SERVICE BULLETIN No. 54 rev. 1

1. WITH REFERENCE TO: Cameron Balloons Ltd. fuel cylinders CB2990 (Alugas)
2. REASON: Cracks in the weld of aluminium fuel cylinders CB2990 (Alugas) - fuel leak.
Release of AD No. G-2022-0010-E (<https://ad.easa.europa.eu/ad/G-2022-0010-E>)

Alert Service Bulletin No 33

Figure 1 - Section indicating Valve Plate

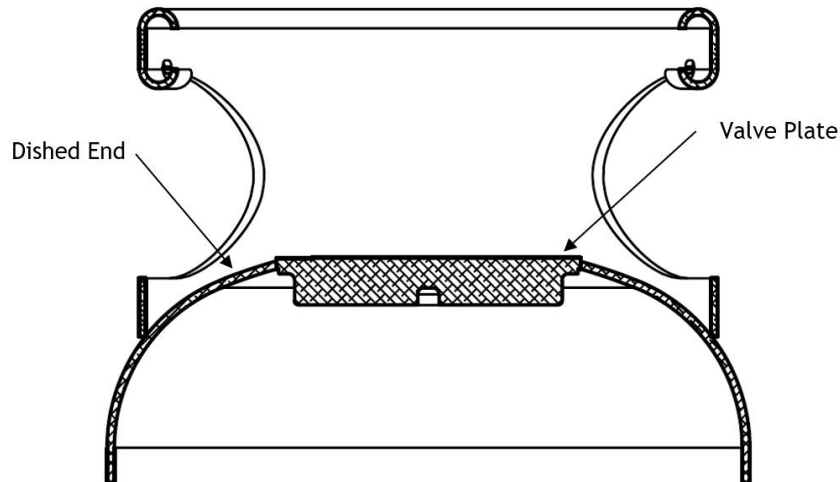
Five CB2990 (Alugas) cylinders have developed cracks in the weld between the cylinder valve plate and the upper dished end. These cracks allow the release of propane from the cylinder. Failures have been observed during periodic inspection (hydraulic pressure test), and leak test. All the in-service failures seen to date have been from the batch of cylinders with serial numbers starting OC.

Within 24 hours of receipt of this bulletin affected cylinders must be checked for leaking around the interface between the cylinder valve plate and the upper dished end using leak detector fluid. Any cylinders found to be leaking must be emptied of fuel immediately. A pilot may carry out this inspection. A satisfactory leak check **does not** release the cylinder to service.

Within 7 days of receipt of this bulletin affected cylinders must be emptied of fuel.
